Background on National Scenic Byway Marker Sign

2D.49.01 NATIONAL SCENIC BYWAYS MARKER:

Figure 2-X

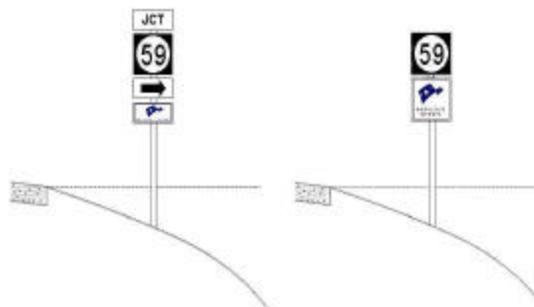
This marker's message, the icon and text together, is the "brand image" developed for the National Scenic Byways Program, see figure 2-X. This marker's primary purpose is to form a connection between the route a byway traveler is driving and travel literature or promotional materials they may be using about the nationally designated byway. Markers also identify the gateway or portal of the byway and confirm the route for travelers. Markers are used to reinforce the traveler's experience and support other forms of traveler information including roadside interpretive materials, maps, route brochures and similar promotional materials. This marker is intended to complement state or local byway logo signing activities.

This marker design is the only acceptable layout. When a byway and road management authority elect to use this marker, it shall be used uniformly along the entire route. This marker shall be placed so that the roadway route markers have primary visibility for the driver, see figure 2-XX. Use of this marker is limited to byways designated by the Secretary of Transportation under the National Scenic Byways Program.

Sign is 24"x 24"
